**STAFF REPORT
KETCHUM PLANNING AND ZONING COMMISSION
MEETING OF JULY 27, 2021**

PROJECT: Crossbuck McNee Townhomes

FILE NUMBERS: P21-025 & P21-026

APPLICATION: Design Review and Townhouse Subdivision Preliminary Plat

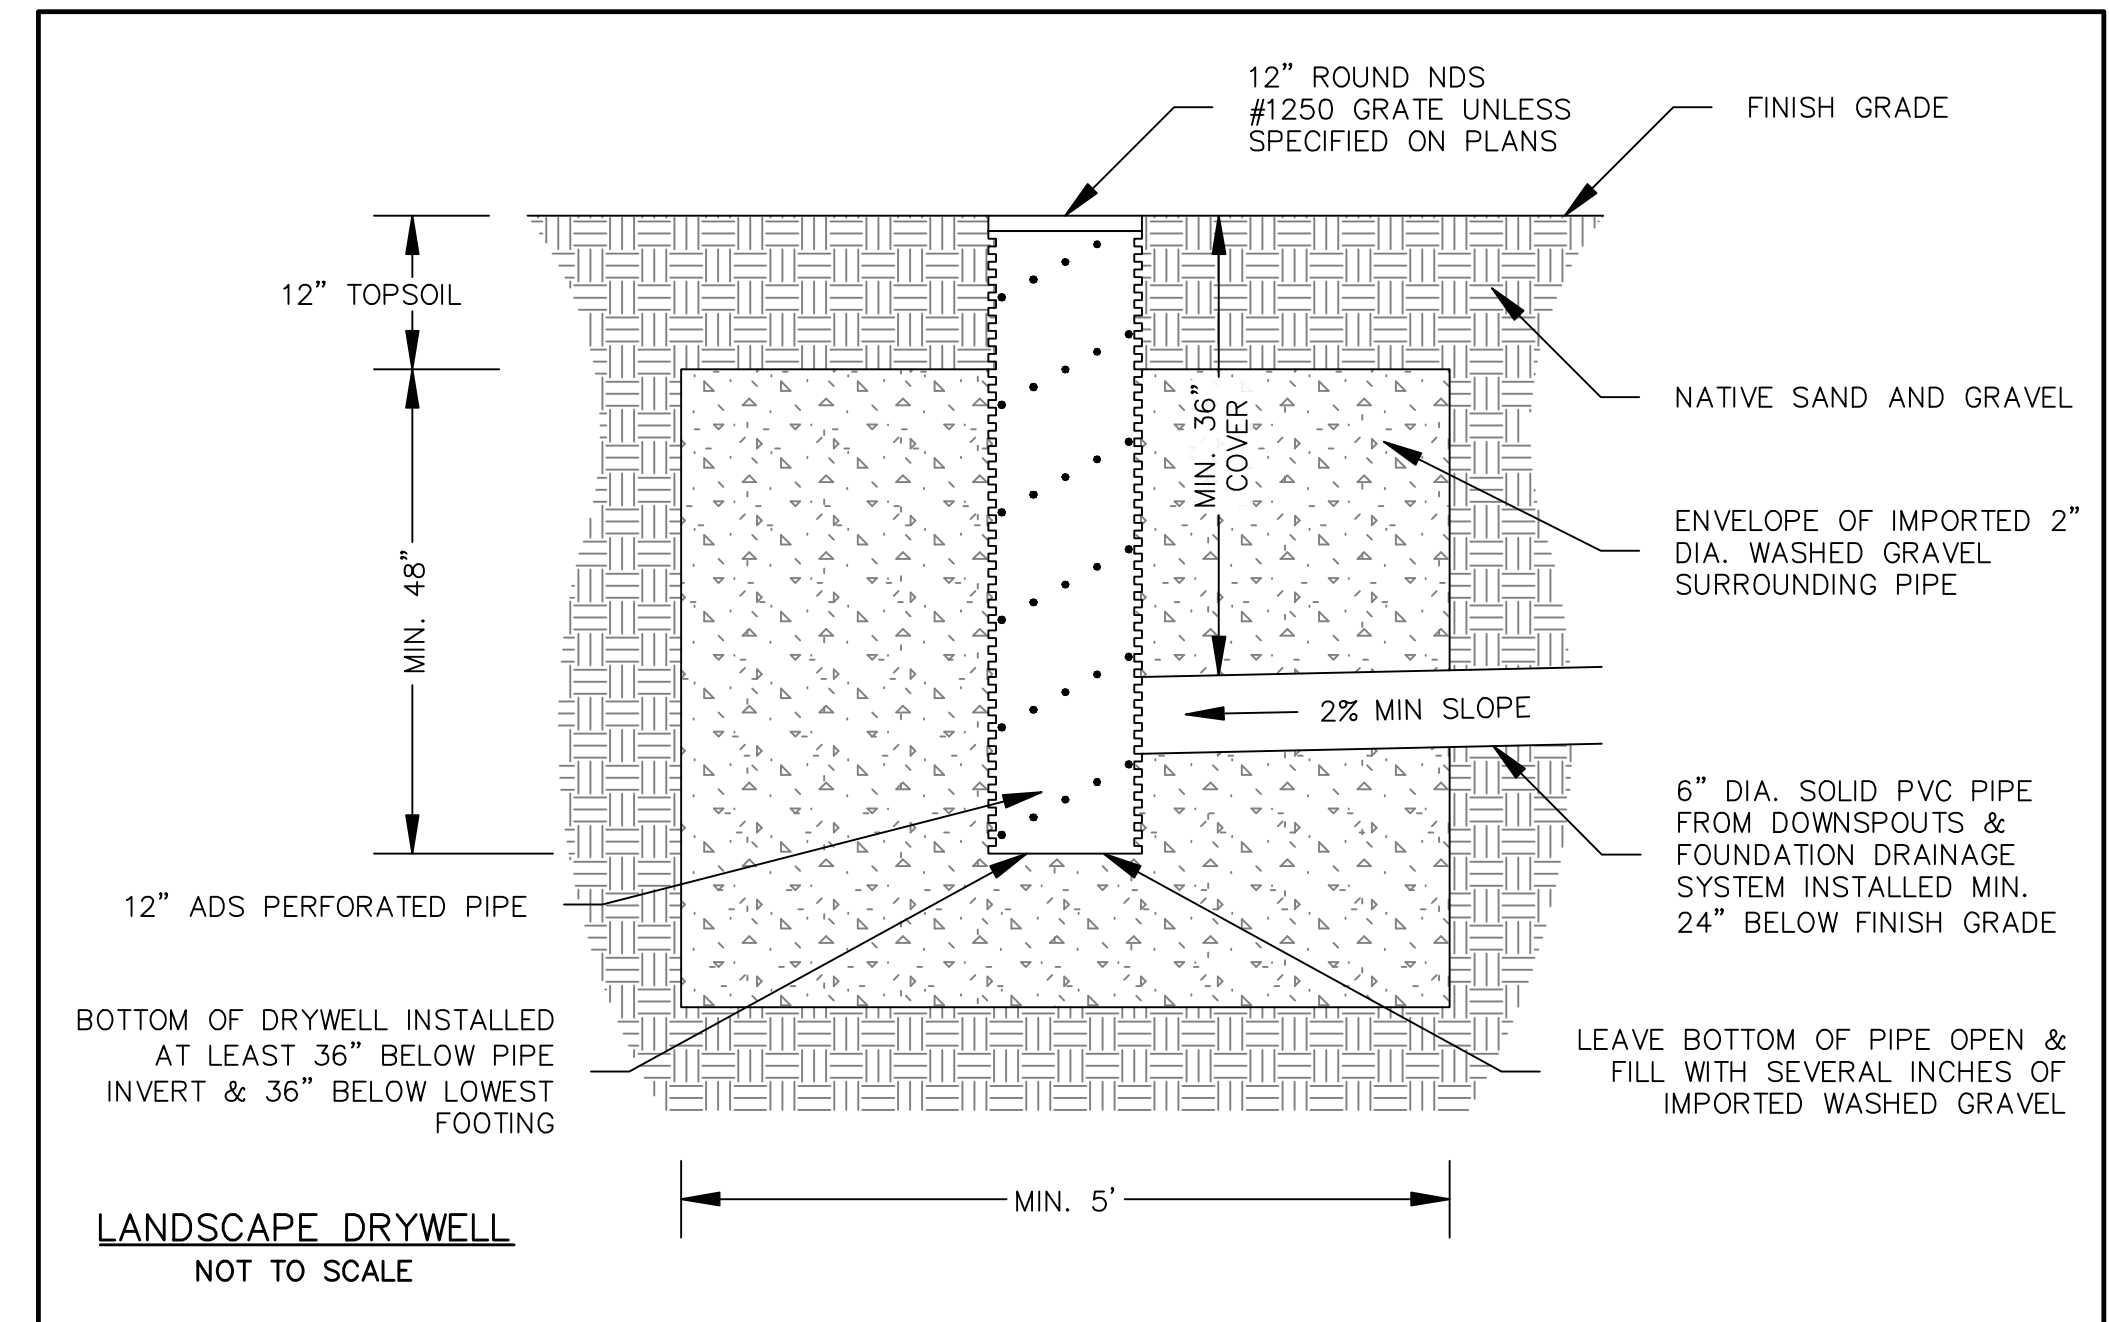
Staff Comments	While the Crossbuck McNee Townhomes project qualifies as a substantial improvement, sidewalks are not required to be installed within this residential neighborhood. The applicant shall improve the right-of-way (ROW) adjacent to the front property line along 7 th Street to City ROW standards for residential roadways. The required right-of-way improvements are indicated on Sheet C2 of the

<p>project plans. Material shall be pervious/permeable to allow drainage. Surface must allow for vehicle parking and be consistent along the entire property frontage. Material within the first eight (8) feet from edge of asphalt shall be distinct from driveway and rest of property in order to visually appear to be available for parking. Grading and drainage improvements must meet the following standards: minimum 5% slope, no obstructions, such as boulders or berms, no buried irrigation systems within the first eight (8) from the edge of asphalt, and no subsurface irrigation lines are permitted beyond the first eight (8) feet, however popup heads are not permitted anywhere in the ROW. No live plant material within the first eight (8) feet from edge of asphalt. Low ground cover plant material, such as turf grass, is permitted beyond the first eight (8) feet. Drought-tolerant species is preferred.</p> <p>Final civil drawings for all associated ROW improvements shall be submitted with the building permit application to be reviewed and approved by the City Engineer and Streets Department prior to issuance of a building permit for the project.</p> <p>See Table 1 for comments and conditions from the City Engineer & Streets Department.</p>

Sheet No:
L1.0

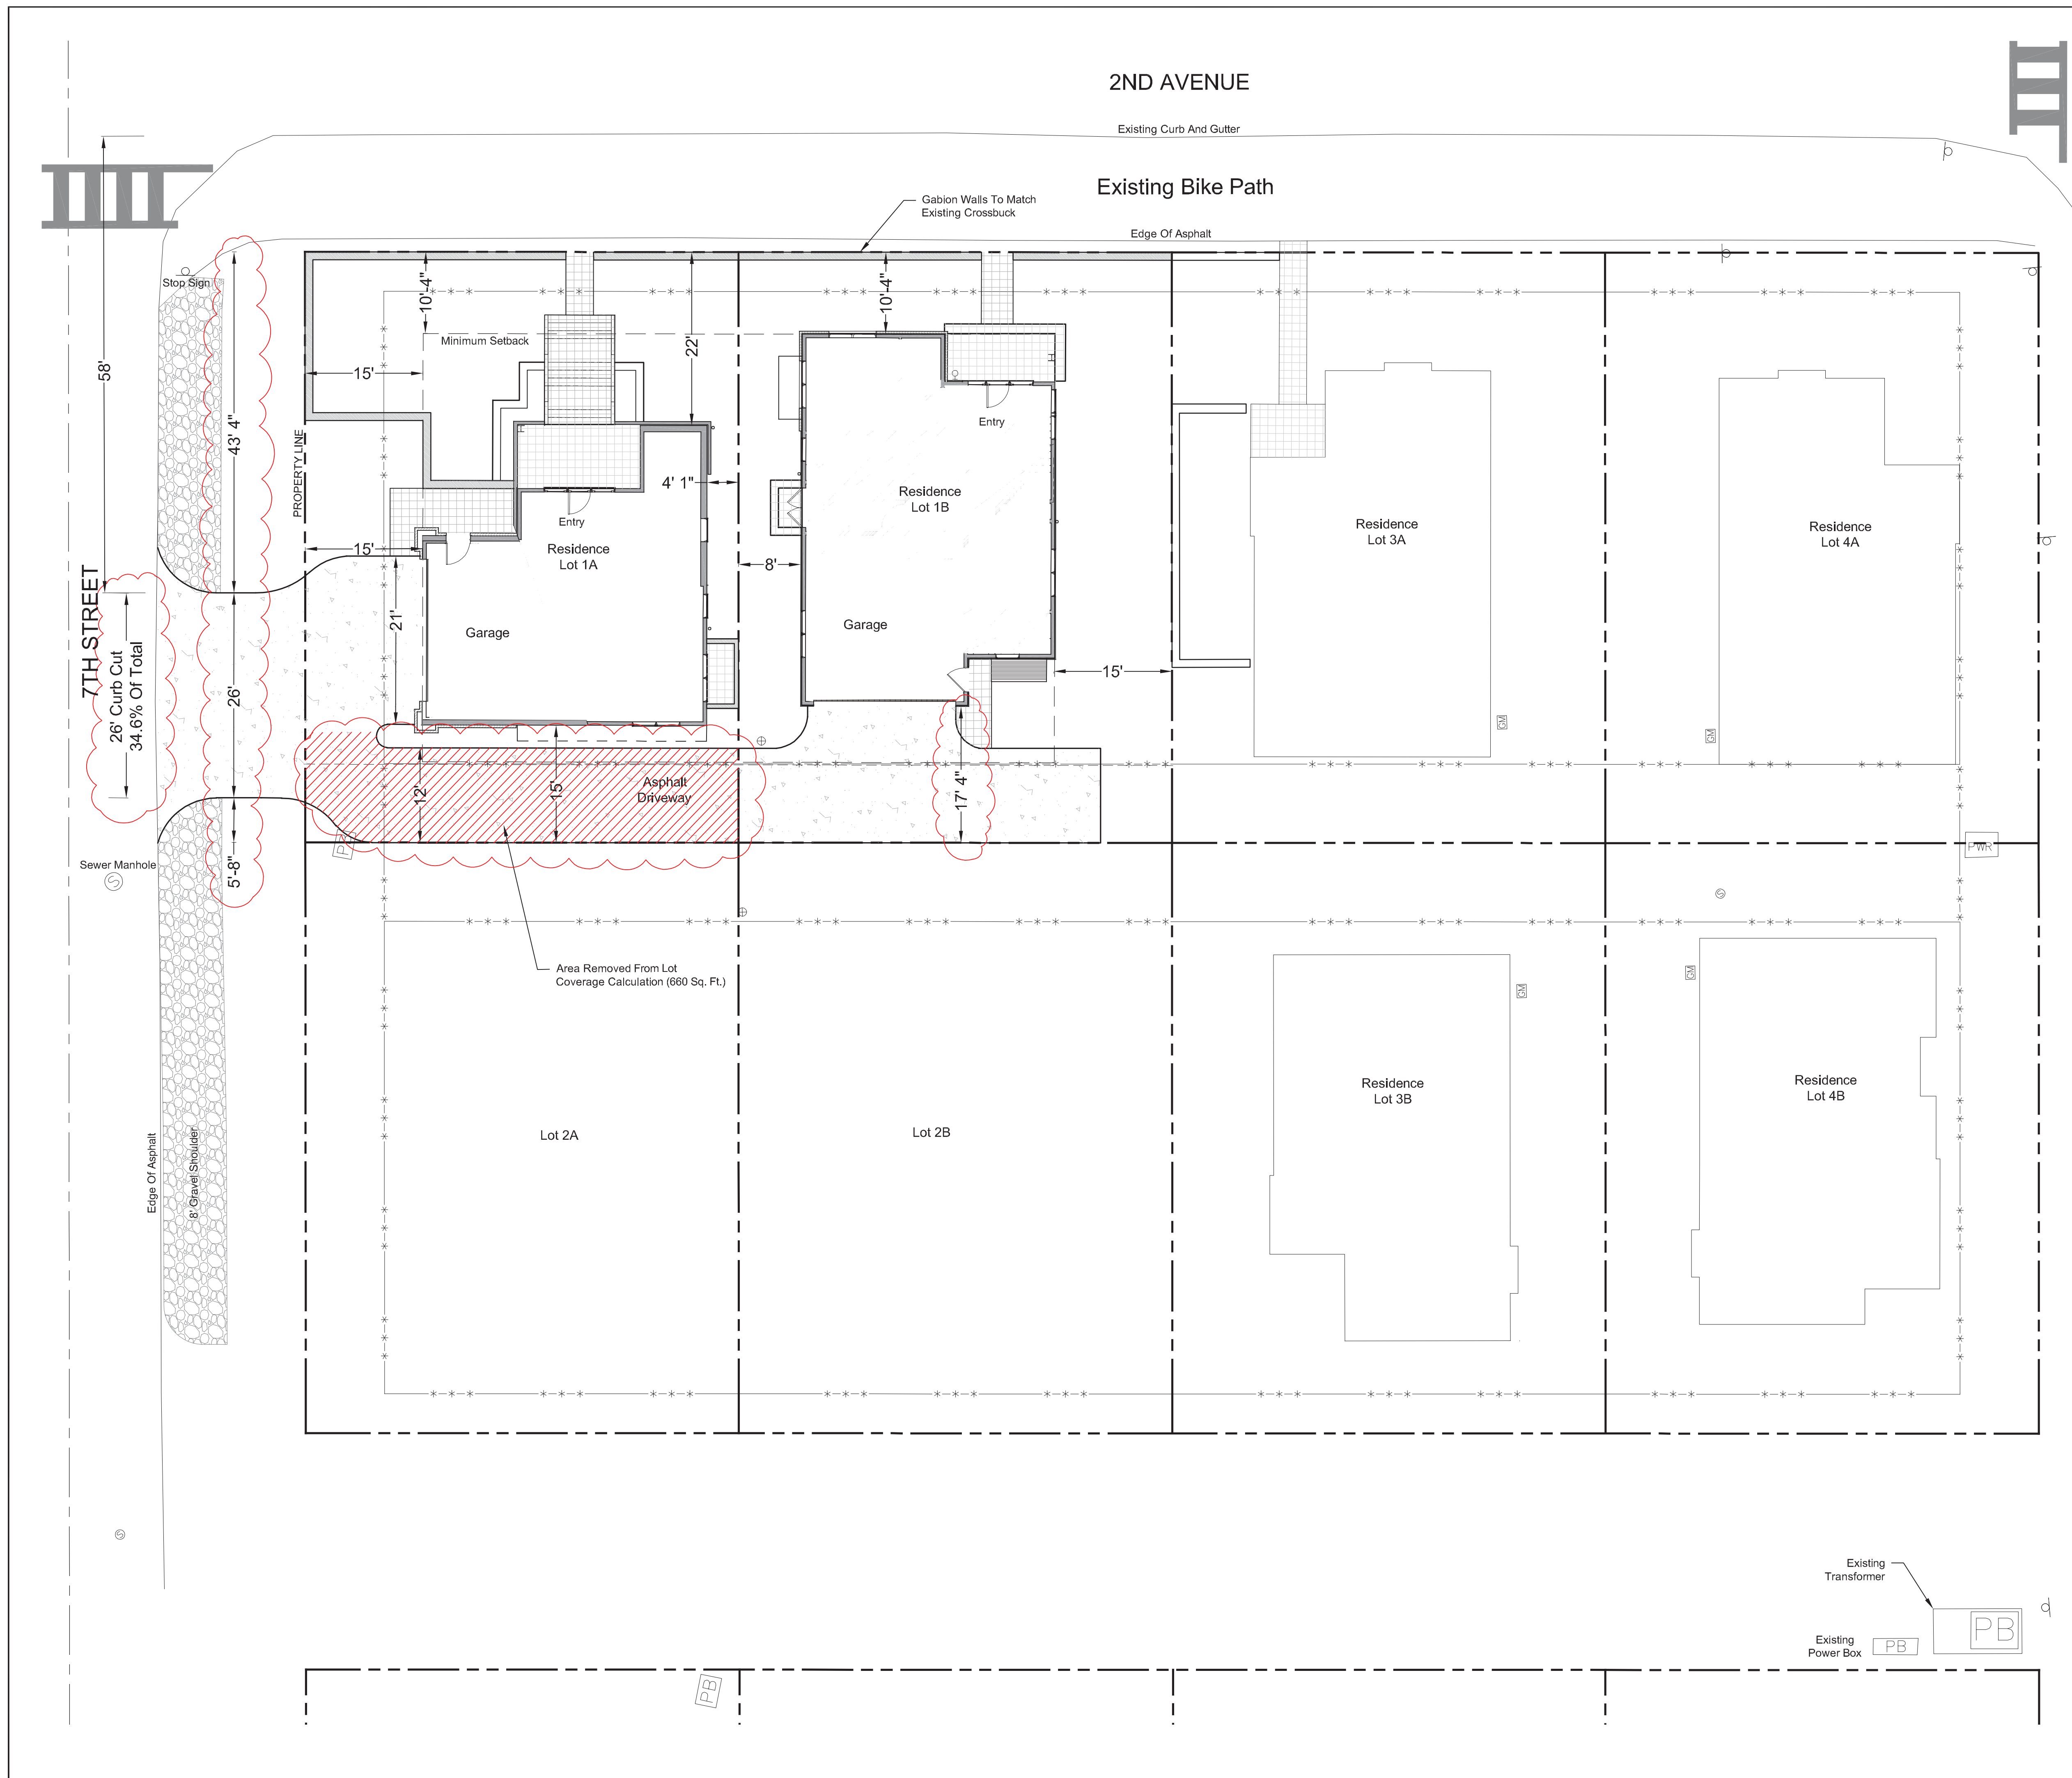
Staff Comments	As specified on Sheet L-1.0, the shared driveway entrance to the townhome development is located 58 feet from the intersection of 7 th Street and 2 nd Avenue. Prior to issuance of a building permit for the project, the City Engineer and Streets Department shall review the civil drawings to ensure adequate sight distances and proper signage for the proposed driveway access.
<input checked="" type="checkbox"/>	<input type="checkbox"/>	<input type="checkbox"/>	17.96.060.G5 Circulation Design	Unobstructed access shall be provided for emergency vehicles, snowplows, garbage trucks and similar service vehicles to all necessary locations within the proposed project.
			Staff Comments	The new multi-family residential development provides unobstructed access for emergency vehicles, snowplows, garbage trucks, and other services vehicles. Unobstructed access to the townhome units is provided from the shared driveway along 7 th Street.

Sheet No:
L2

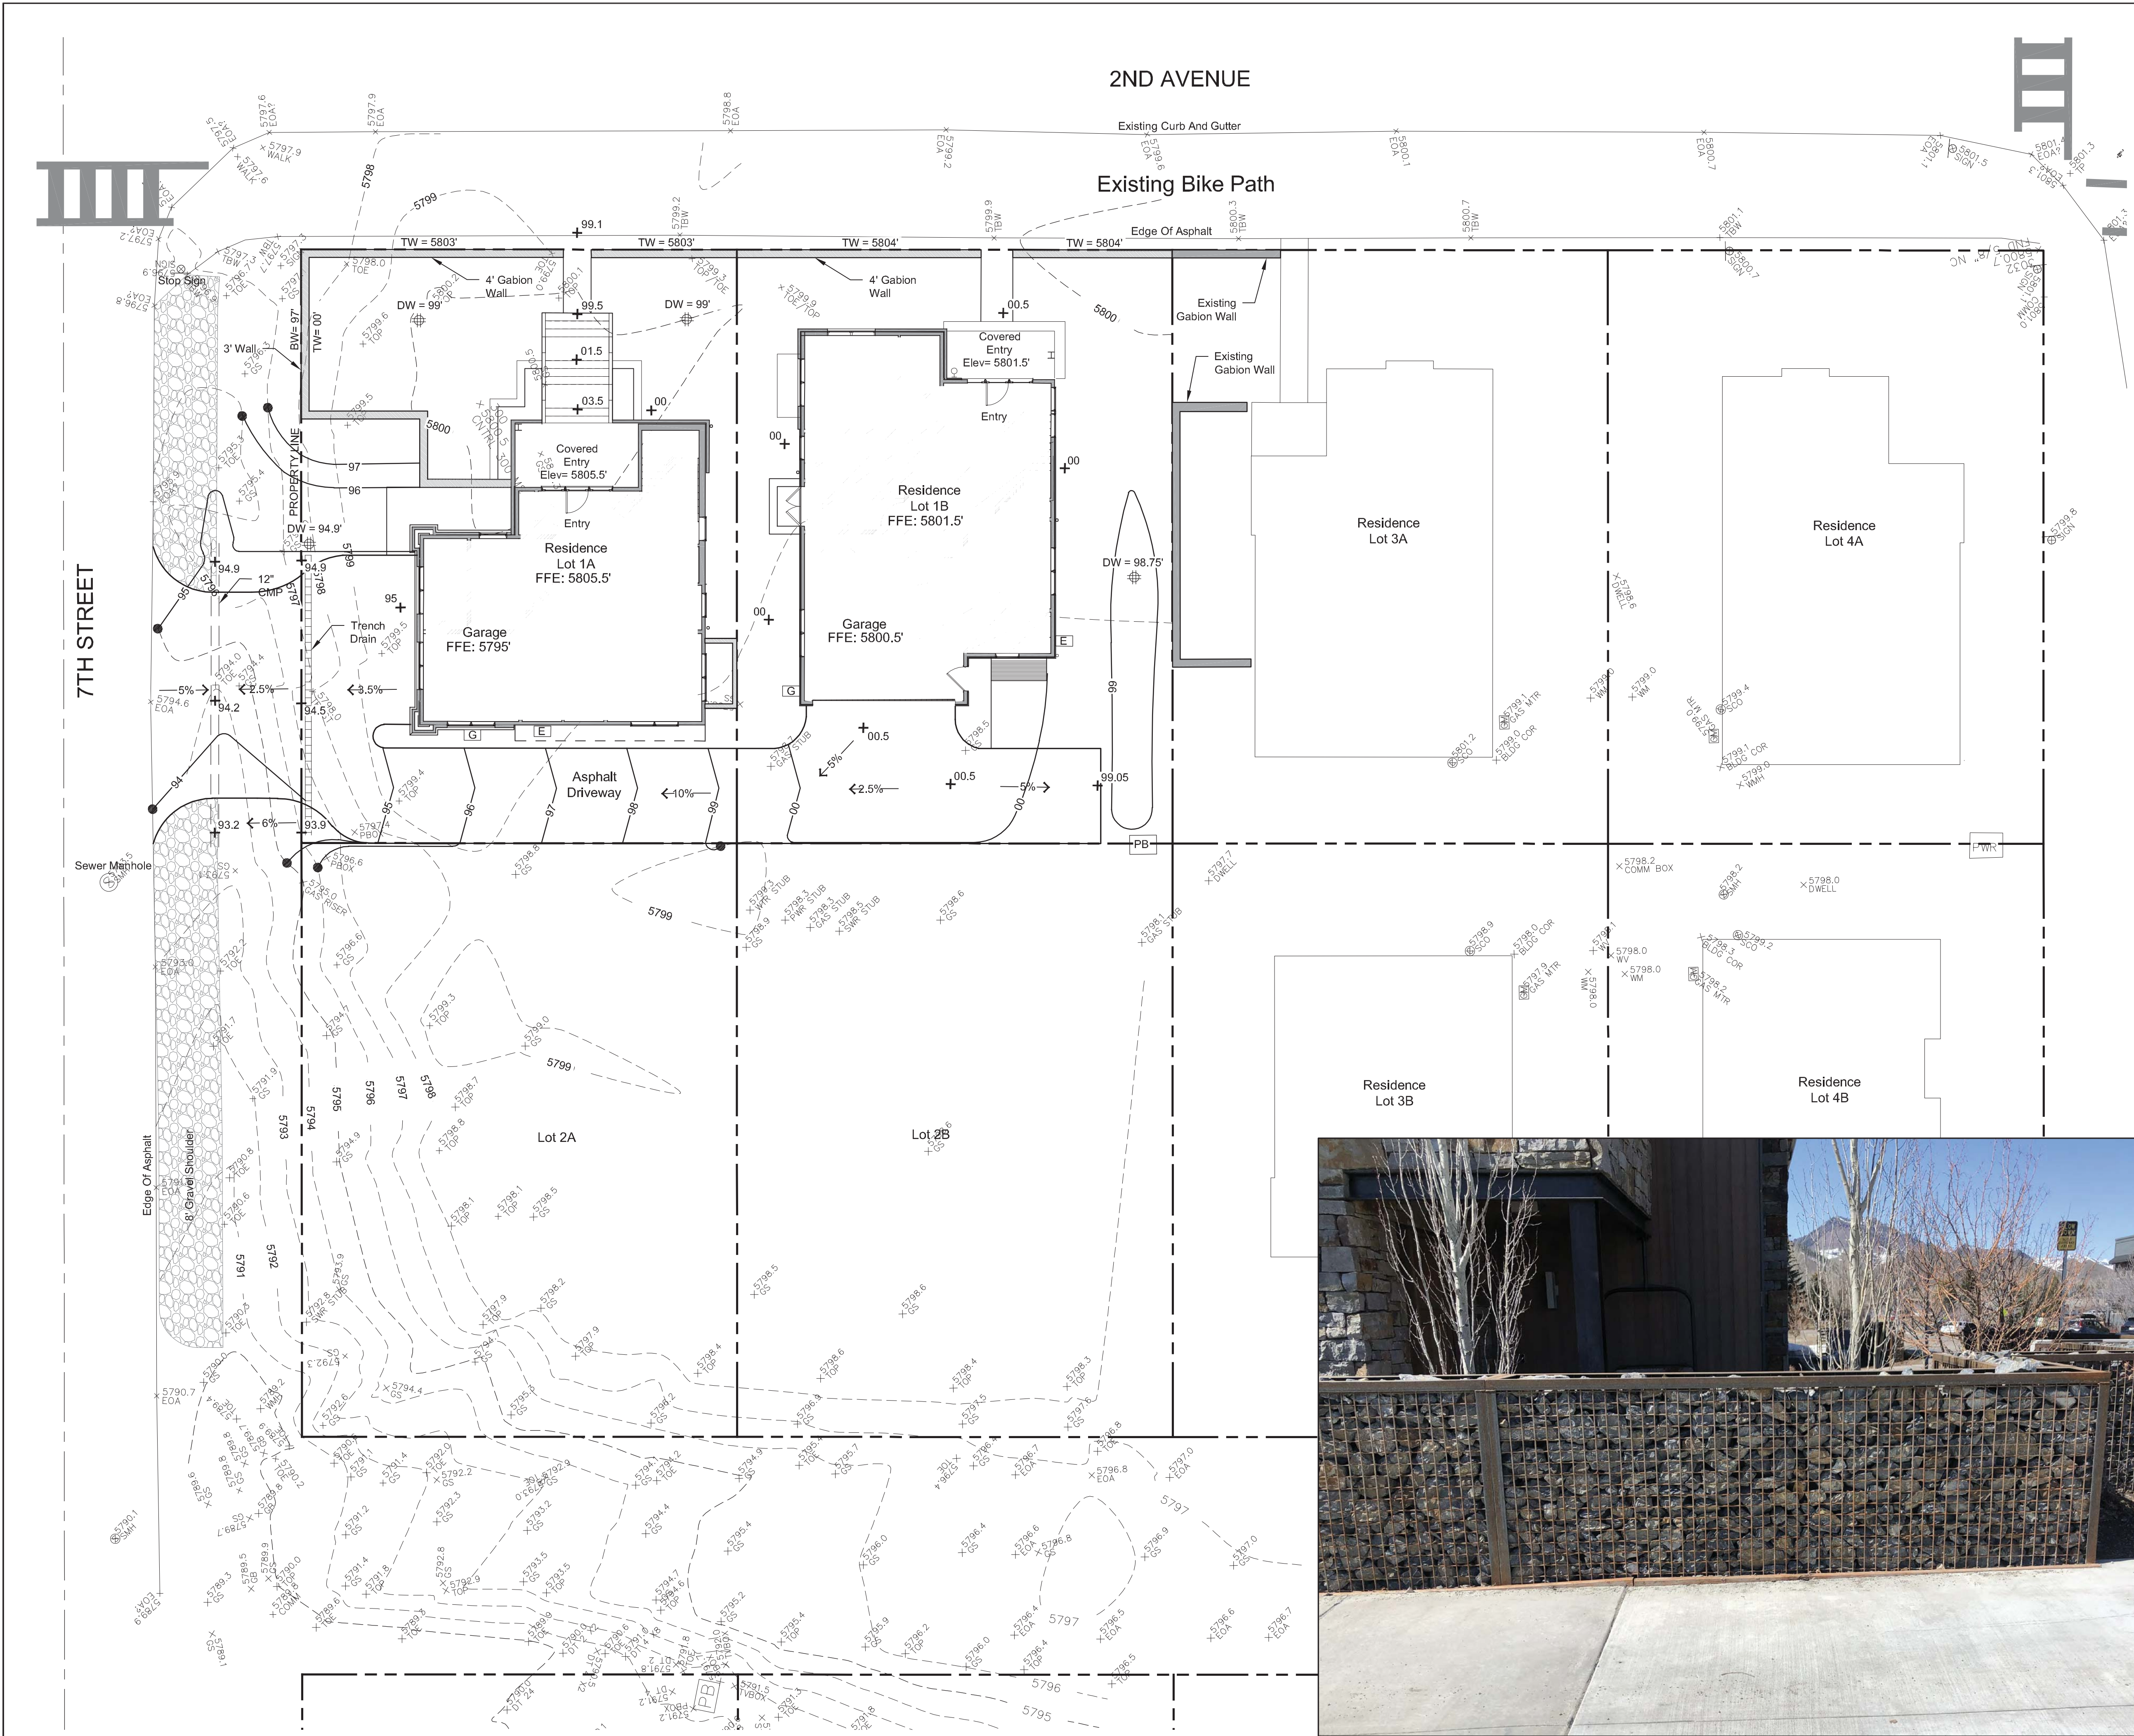
Staff Comments	The project plans include drainage improvements. The drainage improvements are indicated on Sheet L2 and the drywell specifications are provided on the civil drawings.
<input checked="" type="checkbox"/>	<input type="checkbox"/>	<input type="checkbox"/>	16.04.030.J.14	The location of all drainage canals and structures, the proposed method of disposing of runoff water, and the location and size of all drainage easements, whether they are located within or outside of the proposed plat.
			Staff Comments	All drainage improvements have been indicated on the project plans. No drainage canals are required or proposed.
<input checked="" type="checkbox"/>	<input type="checkbox"/>	<input type="checkbox"/>	16.04.030.J.15	Vicinity map drawn to approximate scale showing the location of the proposed subdivision in reference to existing and/or proposed arterials and collector streets.
			Staff Comments	The project plans include a vicinity map.
